Rezoning Transportation Analysis

Petition Number: 2018-047

Date	Description	
04-23-2018	First Review	
05-21-2018	Second Review

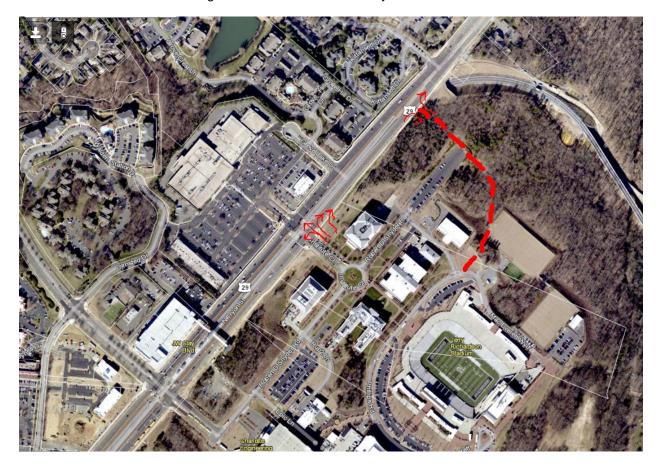
- 5. The petitioner should revise the site plan and conditional note(s) to add a third lane travel lane to the Institute Circle westbound approach (i.e. a single left/thru lane and dual right turn lanes). The dual rights should be channelized, and the pork-chop island should be large enough to serve as a pedestrian refuge with pedestrian signals and pushbuttons to accommodate the pedestrian traffic (see conceptual transportation improvements below).

CDOT has recently remarked and signed the westbound Institute Circle approach to provide a left turn/thru lane and a dedicated right turn lane to help mitigate right turn queuing issues which sometimes stack into the existing roundabout at Robert D. Snyder Road.
